**RE: SINGLE RESPONSE TO AMENDED PLANS (REVISION C) – DA2023/0246,  
NO. 18 HILLCREST AVE, MONA VALE**

<b>DA Address:</b>	18 Hillcrest Ave, MONA VALE
<b>DA Reference</b>	<b>DA2023/0246</b>
<b>Neighbour:</b>	Mr Geoff WEBSTER & Mrs Ruth DOWNES ( <i>Primary Objector</i> ) Owners of: <b>No. 12 Hillcrest Ave, MONA VALE</b>
<b>Stage</b>	Response to Post-Panel Amended Plans (Revision C)
<b>DA description:</b>	Alterations and additions to residential development – construction of a secondary dwelling.

Figure 2: Suggested new location of the proposed secondary dwelling (Source: iObject 2023)

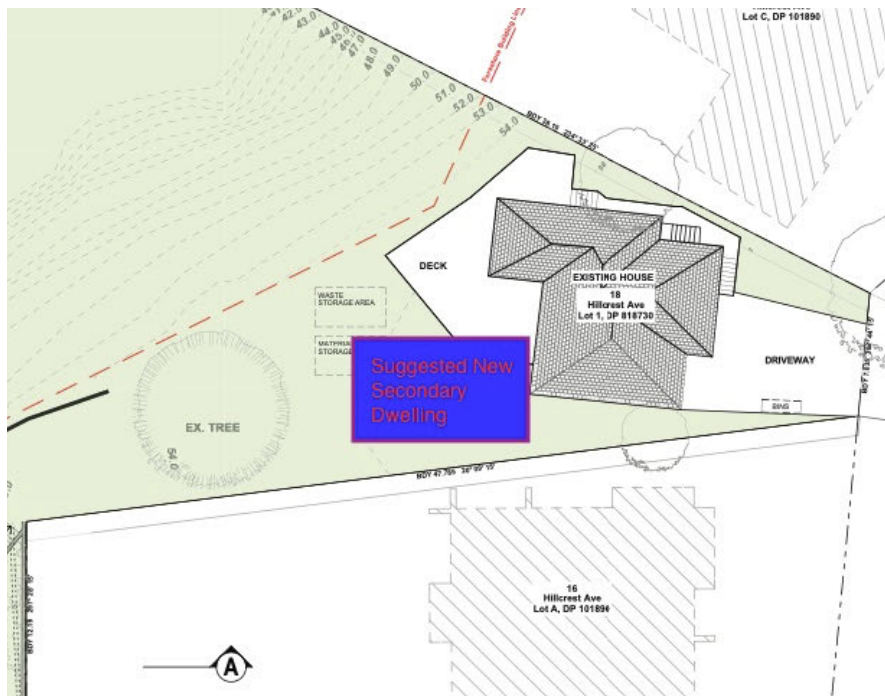
The second version of amended plans hence represent once again a totally insufficient response to the clear gravity of the problems created by the siting in general. The siting will ultimately interrupt the consistent pattern of coastal built forms, at the unnecessary expense of neighbouring and public amenity. A completely different approach is thus needed to offer a compliant development scenario that meets DCP requirements relating to character and scenic protection.

**Proposed Solution:** Re-siting the secondary dwelling closer to the main dwelling (eg. via attached or semi-detached additions).
